ADVISORY BOARD ON RADIATION AND WORKER HEALTH

***REVIEW OF NIOSH/ORAUT PROCEDURES AND METHODS
USED FOR DOSE RECONSTRUCTION***

Review of the Third Set of Procedures (45 procedure reviews)

**Contract No. 200-2004-03805
SCA-TR-TASK3-0003, Rev. 0**

Figure 3.4-1: Estimated Coworker Lognormal Distribution Parameters Mu and Sigma with Trendlines, and Mean, Median, and 95th Percentile of the Dose Distribution, by Quarter

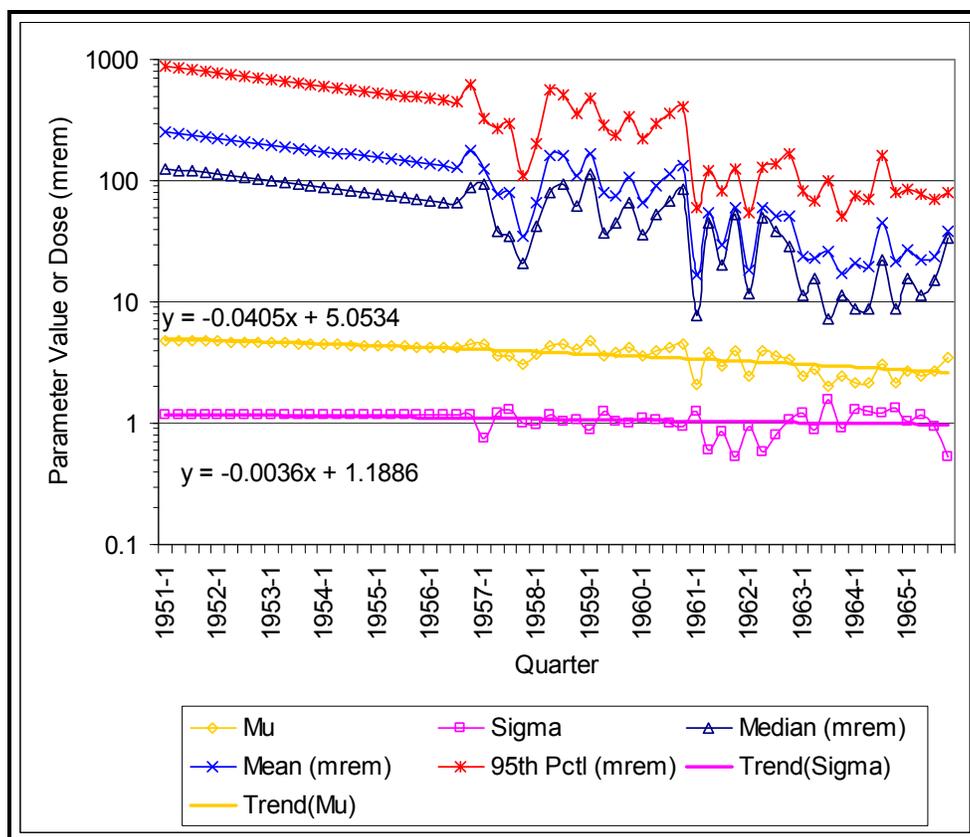
The scaling procedure also assumes that suitable lognormal distributions for the coworker population in the time periods prior to 1961 are available from other sources. The parameters μ and σ for the lognormal distributions reported in OTIB-0013, Table 1, are plotted in the lower two curves in Figure. Also shown in Figure are the trend line linear regressions for each parameter. The three upper curves in the figure show the median, mean, and 95th percentile of the lognormal distributions. A noticeable dip in the median, mean and 95th percentile occurs in 1961, when more-widespread monitoring was adopted. Prior to this, only workers thought to have higher potential for exposure were being monitored. After 1961, the dose distributions have remained at lower levels. Note that the dip in 1961 occurred mainly due to the reduction in the parameter μ , while σ actually increased by a small amount. These effects are what would be expected if workers at the lower end of the distribution begin to be tested while the previously monitored, mostly higher, doses remain somewhat the same before and after 1961. These changes would be expected to increase the variance and decrease the median.

Note that a similar dip occurred in 1958, but dose levels quickly recovered. This suggests that the variability in measured dose levels was greater prior to 1961 than after, because a smaller number of workers were being monitored and the quarterly doses to these workers were more variable. The parameter values for the coworker lognormal distributions in the early years appear to be based on simple backward extrapolation of coworker distributions in later years. No

Figure 3.9-1: 1-Year Doses, Excluding the Respiratory Tract

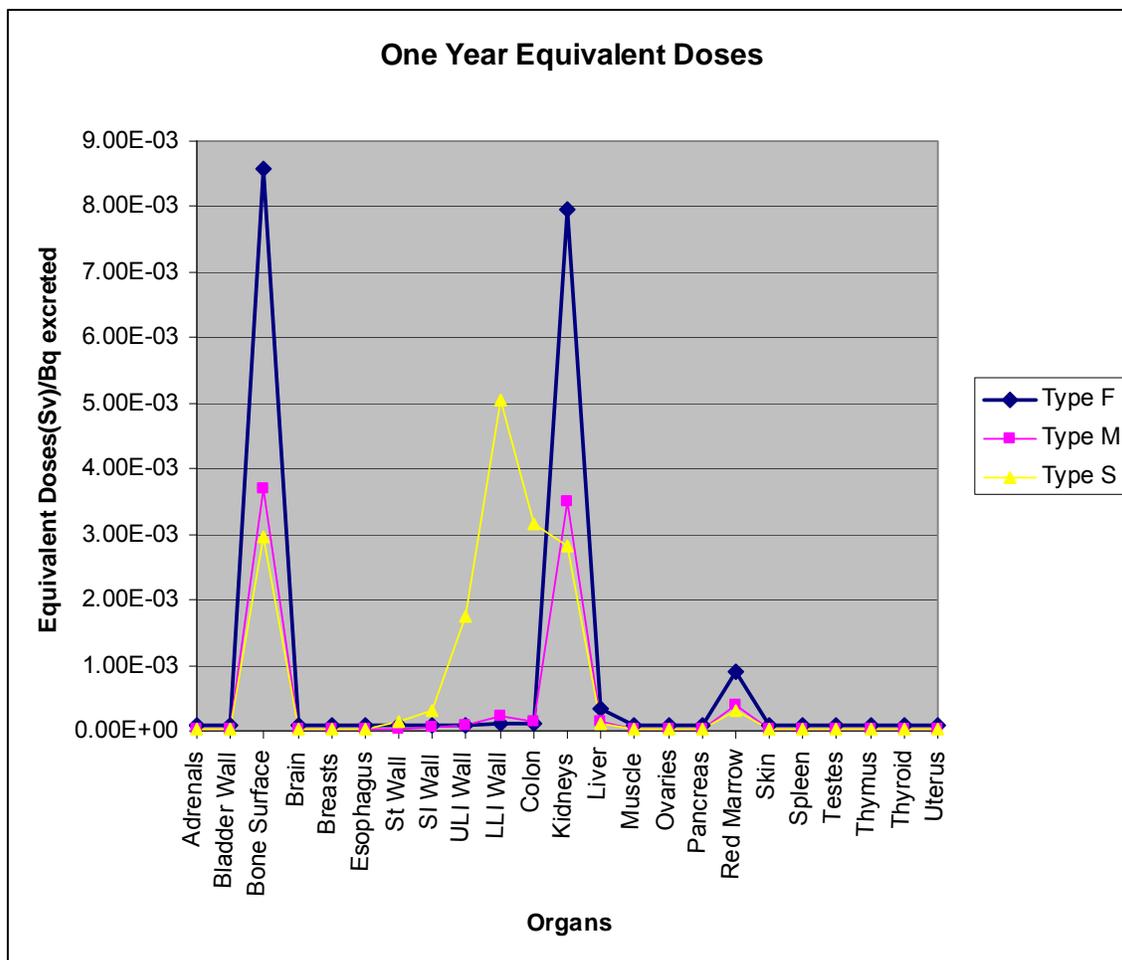
Figure, below, is used to illustrate these findings. It was calculated for a worker exposed for 1 year to chronic constant daily intakes. The 1-year committed equivalent doses to the different organs, per Bq U-234 excreted after the weekend at the end of the working year, is shown. Thus, assumptions for the values on Figure are:

SC&A finds that the assumption that doses should be assigned based on exposures to uranium compounds of solubility Types M and S, without considering Type F compounds, is not claimant favorable for many cancer sites. This assumption does not follow instructions given in 42 CFR 82. The 42 CFR 82, specifically states that:

Figure 3.12-1: Assumed Pu-239 Intake, 1951 to 1988, 50th Percentile Composite Results, Type S

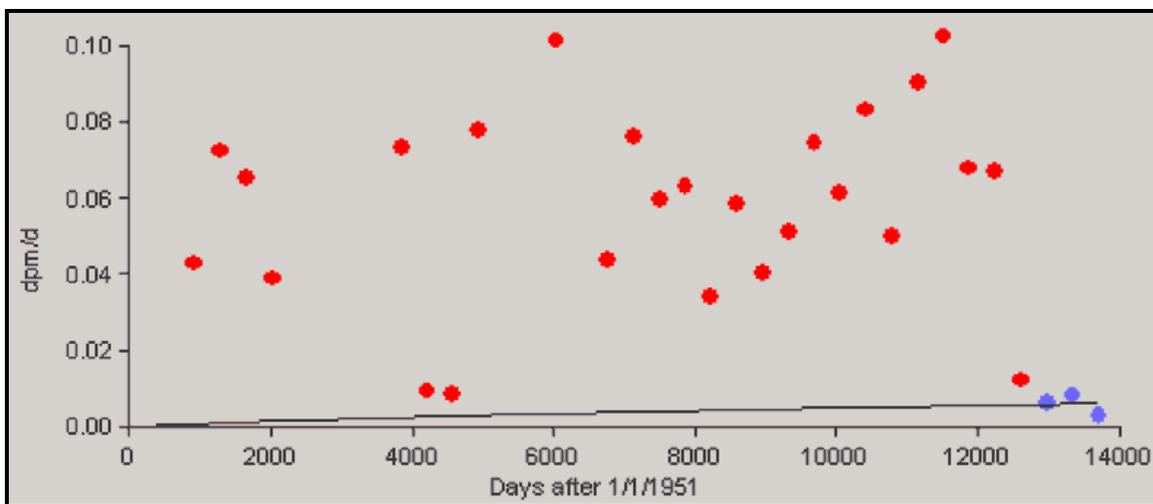
model for reconstructing doses, as can be observed by the red dots in Figure (i.e., OTIB-0034, Figure A-23).

Figure 3.14-1: Lognormal Representation of 1954 Third Quarter Results

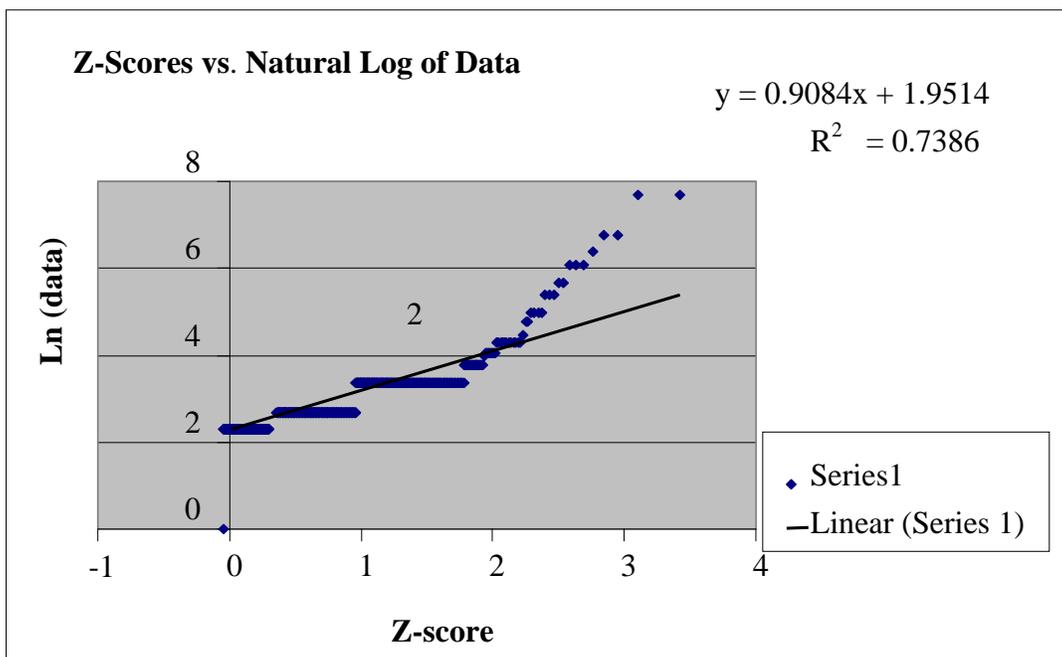
ascending values order) is 300 µg/L. There are 78 values that are higher than the 95th value (100 µg/L). The 50th percentile (GM) is 10.6 µg/L.

- **2nd Quarter:** The 99th percentile as calculated by the lognormal equation is 68.3 µg/L and the 99th value is 600. There are 55 values that are higher than the 95th value (60 µg/L). The 50th percentile (GM) is 8.6 µg/L.
- **3rd Quarter:** The 99th percentile as calculated by the lognormal equation is 58.44 µg/L and the 99th value is 150 µg/L. The 50th percentile (GM) is 7 µg/L. In this quarter the difference between the 95th percentile and the 50th percentiles value is small, but the lognormal representation of results shows problems in the representation of the positive values, as can be illustrated by Figure, extracted from NIOSH data files, for 1954.

Figure 3.14-2: Lognormal Representation of 1954 Fourth Quarter Results

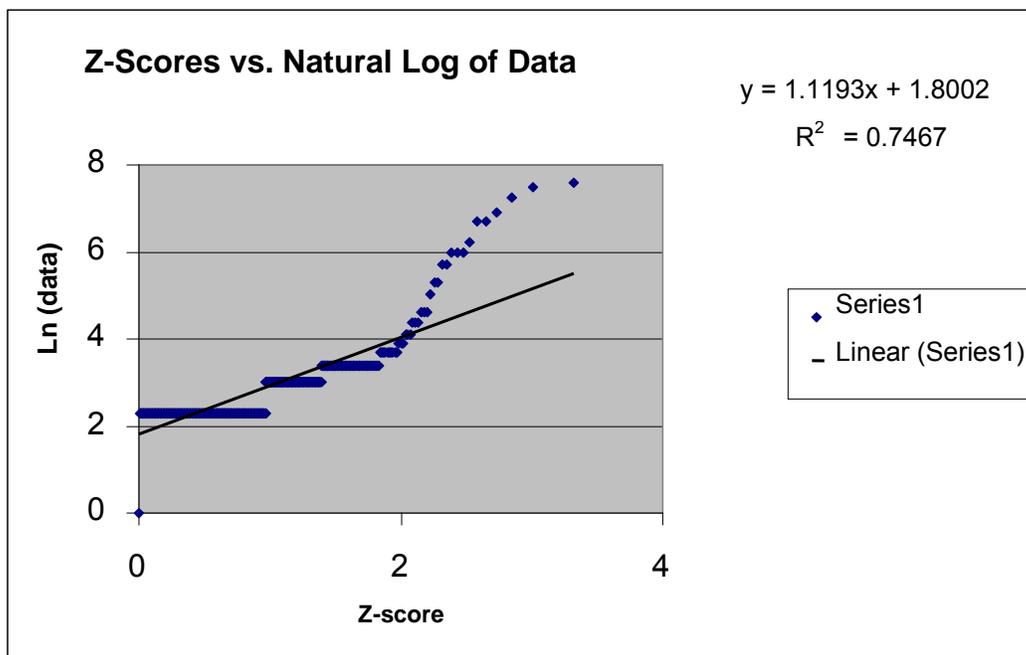
- **4th Quarter:** The 99th percentile as calculated by the equation is 82.9 µg/L and the 99th value is 300 µg/L. The R^2 for the equation is 0.7467, with larger discrepancies on the high-end of the curve, as shown in Figure, extracted from NIOSH PGDP U 1954 file. The 50th percentile as calculated by the lognormal equation is 6.05 µg/L.

The misrepresentation of the higher results by the lognormal curves persists until the 1980s, when the problem practically disappears.

Figure 3.14-3: Type F Material Theoretical Fit Versus 50th Percentile Excretion Rates

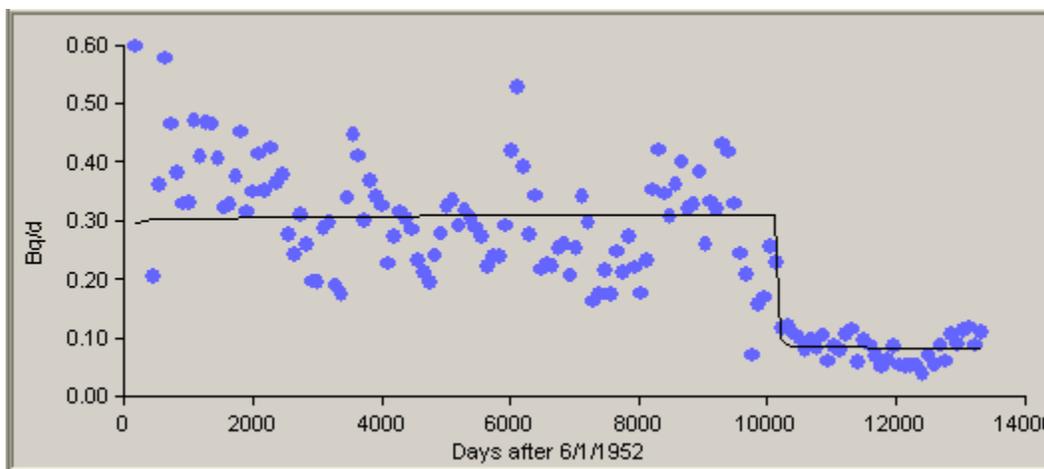
As illustrated by Figure, the model intake rates do not reproduce exactly the 50th percentile of each period of time analyzed. In some time periods, the dose will be calculated using an intake rate that corresponds to urinary excretion values smaller than the 50th percentile of the excretion rates of the workers for that time period. This is particularly true in the earlier periods of time.

Figure 3.15-1: Predicted Plutonium Bioassay Results (line) Calculated using IMBA-Derived Pu Intake Rates Compared with Measured Pu-in-Urine Results (dots), January 1, 1952, to December 31, 1961, 50th Percentile, Type M
(Source: OTIB-0038, Figure B-21)

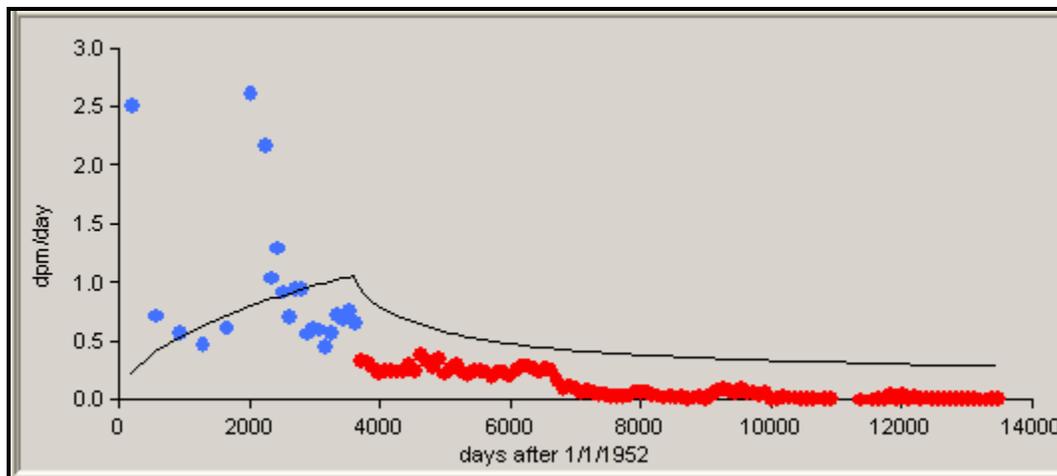
The model intake rates do not correspond to the 50th percentile of each period of time analyzed. As shown in Figure , in some time periods, the dose will be calculated using an intake rate that corresponds to urinary excretion values smaller than the 50th percentile of the excretion rates of the workers for that time period.

Figure 3.25-1: Comparison of Recorded to Estimated Doses

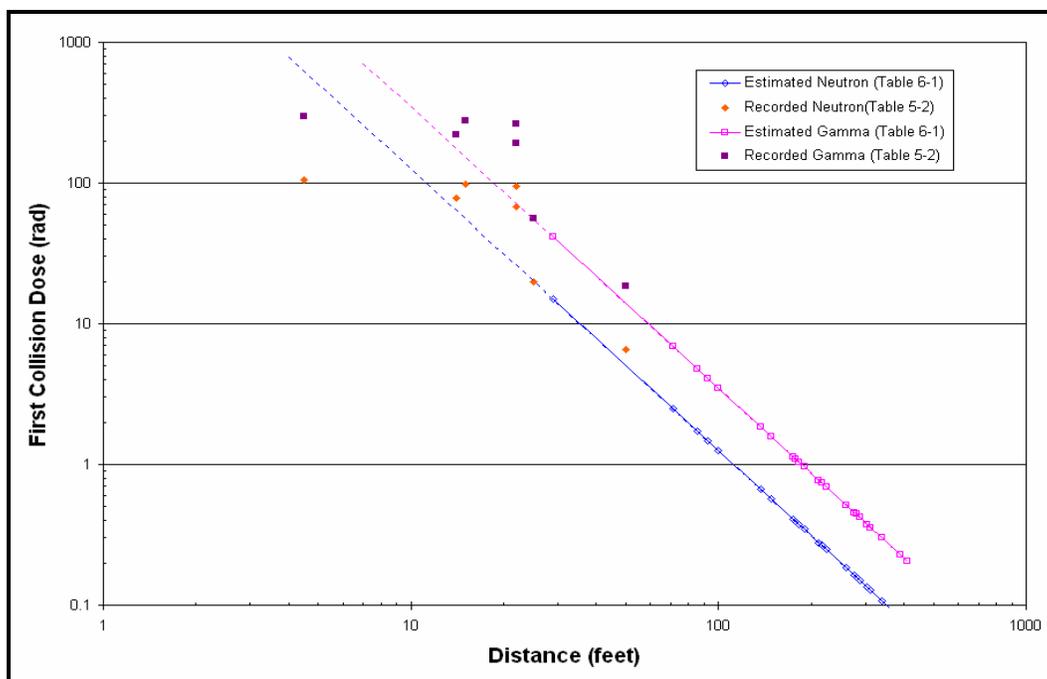
Most of this OTIB employed scientifically valid protocols for reconstructing doses. However, one area of technical comparison/validation was not analyzed and considered. This consists of comparing the neutron dose results obtained by sodium analysis at various distances to those obtained by inverse-square of the distance for the two workers (F and G) at 25 ft, which were used to estimate the dose to other workers further away from the accident. If the dose versus distance of the data in Table 6-1 for workers #8 and #10 - 31 (which are based on the sodium analysis of workers F and G) are plotted on a log-log scale, as shown in Figure, a straight line can be drawn connecting these data points and extended to smaller and larger distances. If the individual doses obtained from the sodium activation analysis of workers A - H are then plotted as a function of distance on the same graph, Figure shows that the latter data points do not fall on the predicted dose line as a function of distance.

Furthermore, as shown by Table, workers’ B, C, D, and E predicted neutron doses (by the results of workers F and G; 20 rem at 25 ft.) are all significantly less than the actual measured dose by sodium activation analysis. The predicted dose for worker A dose is significantly more than that which was measured, but the uncertainty in distance and geometry (i.e., 3–6 ft) associated with this close of distance precludes the use of this data point for comparison.

Figure 3.27-1: Linear Plot of Plutonium Oxide Excretion Rate for Various Fits

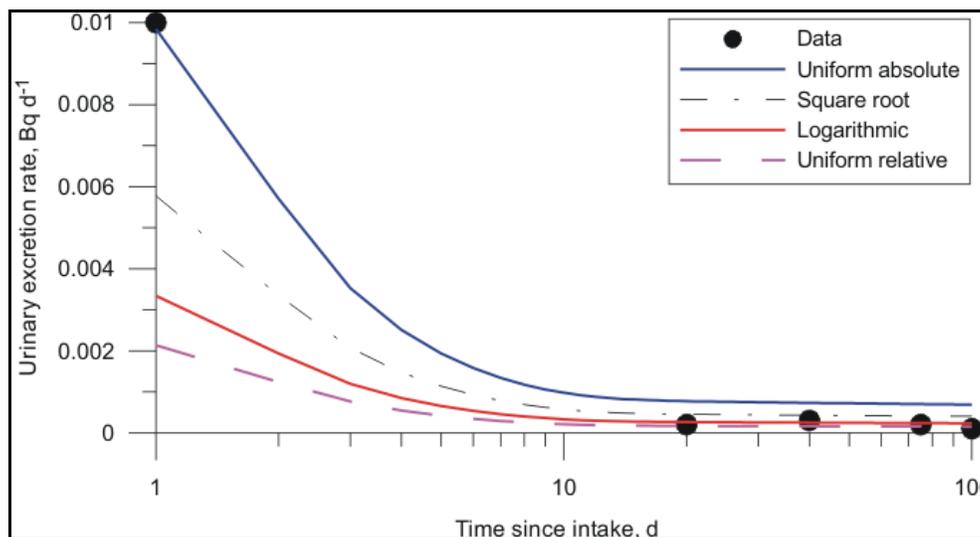
The “uniform absolute” error assumption appears to give the best by eye fit to the data because this is the only fit that comes close to the first data point, while still not appearing too far from the last four data points. The other fits are much closer to the last four data points, because the errors associated with these data are much smaller than that associated with the first point. Consequently, since the shape of the curve is fixed (by the ICRP Publication 67 plutonium biokinetic model), these other fits cannot represent the first data point as well.

Before jumping to the conclusion that the assumption of uniform absolute error is “best,” it is instructive to view the data and fits plotted on a logarithmic scale. [Figure below].

Figure 4.7-1: Comparison of Uncensored Data from a Lognormal(0,1) Distribution versus Censored Distribution with a Linear Distribution of Values Substituted for Censored Data

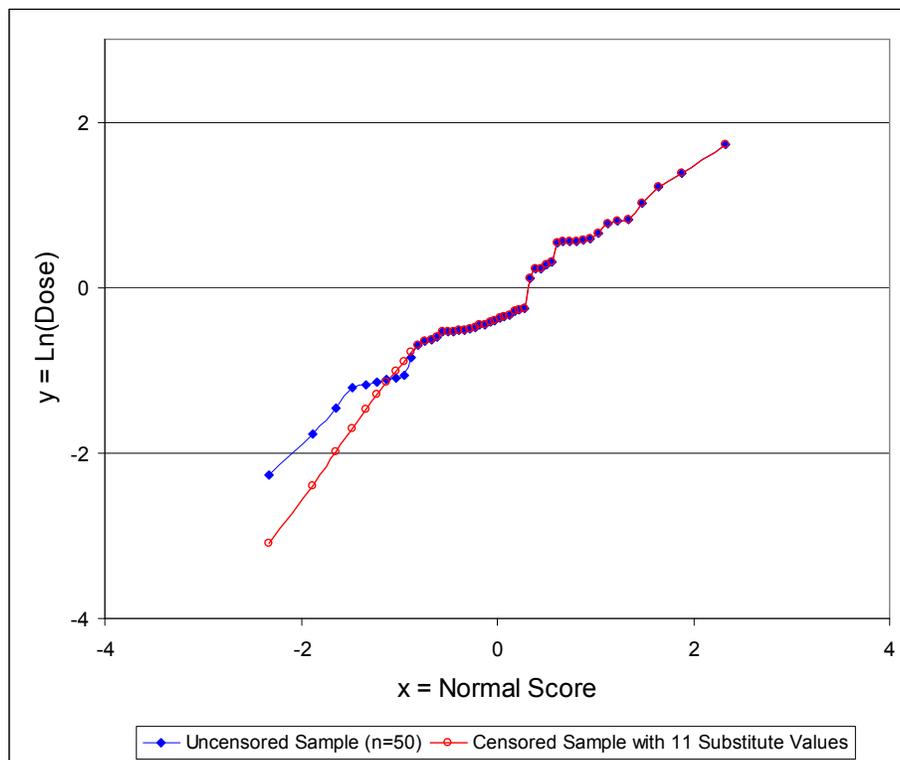
The use of a linearly spaced distribution of values as substitute values for measurements below the MDL is illustrated for a hypothetical case in Figure, below. The blue symbols represent a sample of 50 data points from a lognormal(0,1) distribution. For this illustration, the lowest 11 data points are considered censored (i.e., below the MDL). The open circles at the lower left of Figure represent 11 substitute values developed using the linearly spaced distribution. Note that the substitute values fall below the original data points, indicating that use of the linearly spaced substitute values is not claimant favorable. This recommendation should be removed from the procedure.
